# IEC TC57 WG16

## MAINTENANCE REQUEST

Date of submission:	18/01/2023
Submitter Name:	Jan Owe
Organisation:	Svenska kraftnät
E-mail:	<a href="mailto:jan.owe@svk.se">jan.owe@svk.se</a>
Maintenance Request ID	ebIX® 2022/015
Maintenance Request Version	3 (update date 15/03/2023)
Maintenance Request title	Add the phaseCount attribute to the MarketEvaluationPoint class in ESMP (IEC62325-351 / ESMPClasses / MarketEvaluationPoint).

#### 4.2.3 Snapshot of the update in IEC 62325-351 before

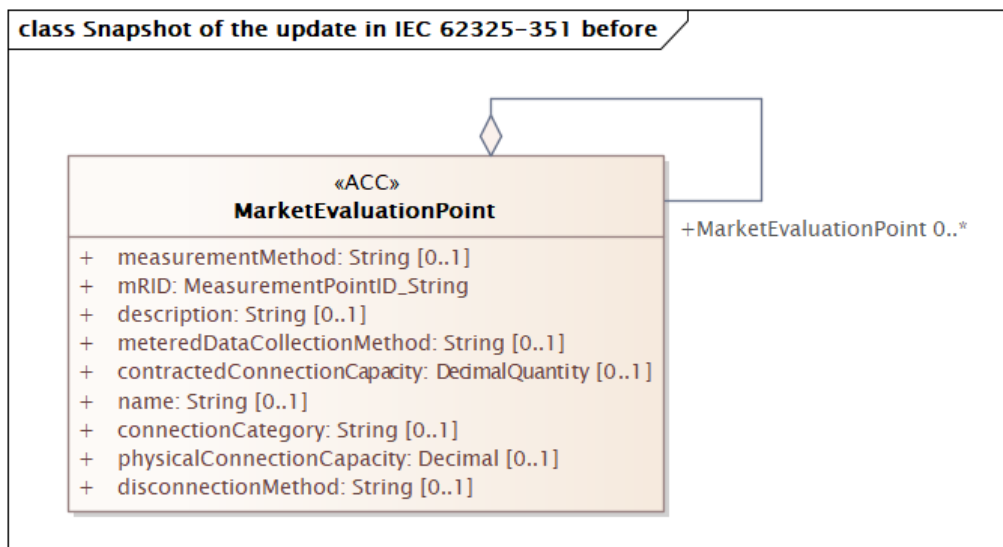
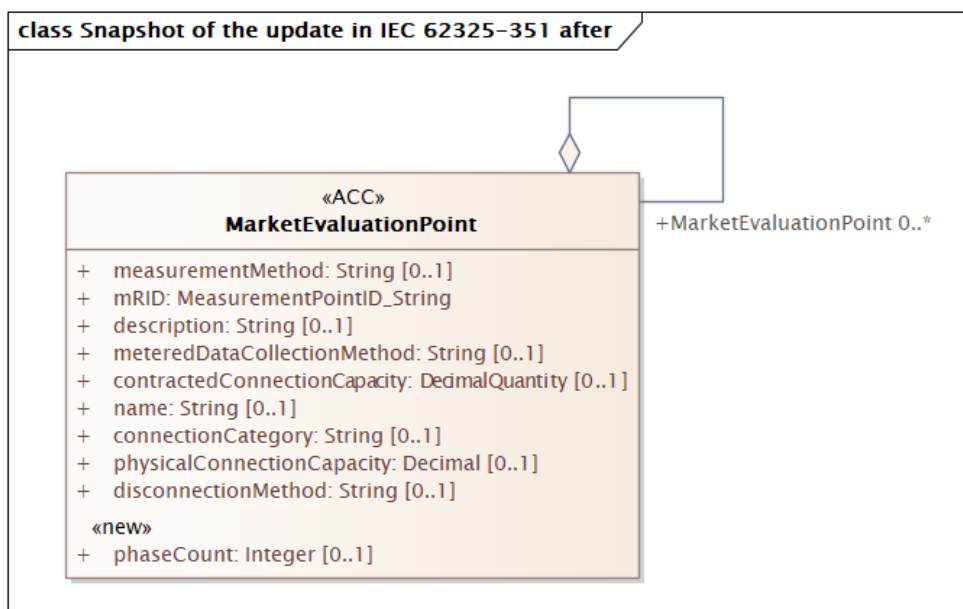
Add the phaseCount attribute to the MarketEvaluationPoint class in ESMP (IEC62325-351/ESMPClasses/MarketEvaluationPoint). The datatype of the phaseCount attribute is suggested to be “«primitive» Integer”.

Supported number of phases, typically 0, 1 or 3.

This definition is proposed copied to the new phaseCount attributes in 62325 and ESMP.
